Access Compliance Report

Public Rights-of-Way

(Curb Ramps)

Intersection ID: 46918	Main Street: BLUE_ASH_LN	Cross Street: PONDEROSA_PINE_LN	Location: NE
ADA ID: 6BB36C15895F	Ramp Type: PerpDiag	Initial Pass/Fail: Fail	Overall Compliance: No
Severity Score: 33.75			
Codes/Mitigation Info/Possible Solution		Field Measurements/Component Compliance

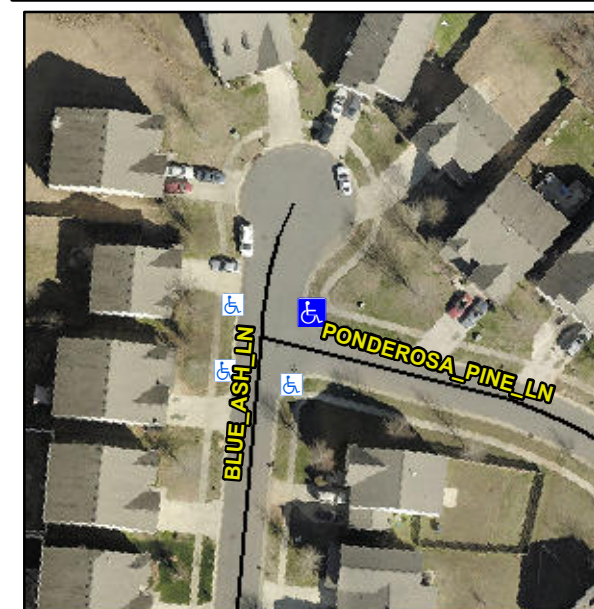
Not Found, R304.5.1, R304.2.2, R304.5.3

Compliance	Description	Data	Compliance	Description	Data
N/A	Ramp Length (in)	86.5	No	Ramp Slope (%)	8.9
No	Ramp Width (in)	46.5	No	Ramp XSlope (%)	5.9
N/A	Flare Type LT	N/A	N/A	Flare Type RT	N/A
N/A	Flare Slope LT (%)	N/A	N/A	Flare Slope RT (%)	N/A
N/A	Flare Traversable LT?	N/A	N/A	Flare Traversable RT?	N/A
N/A	Landing Length (in)	N/A	N/A	DWS Provided?	N/A
N/A	Landing Width (in)	N/A	N/A	DWS Contrast?	N/A
N/A	Landing Slope (%)	N/A	N/A	DWS Length (in)	N/A
N/A	Landing X Slope (%)	N/A	N/A	DWS Full Width?	N/A
N/A	Landing Curb? (Y/N)	N/A	N/A	DWS Offset (in)	N/A
N/A	Shared Landing?	N/A			
N/A	Gutter Ponding?	N/A	N/A	Gutter Slope (%)	N/A
N/A	Gutter Lip Ht (in)	N/A	N/A	Gutter X Slope (%)	N/A
N/A	Painted X Walk1?	No	N/A	Painted X Walk2?	No
	X Walk 1 Direction	To W		X Walk 2 Direction	To S
N/A	X Walk 1 Width (in)	N/A	N/A	X Walk 2 Width (in)	N/A
	X Walk 1 Slope (%)	0.3		X Walk 2 Slope (%)	4.0
	X Walk 1 X Slope (%)	4.2		X Walk 2 X Slope (%)	2.2

Remove & Replace Curb Ramp With Two New Directional Ramps or Equivalent.
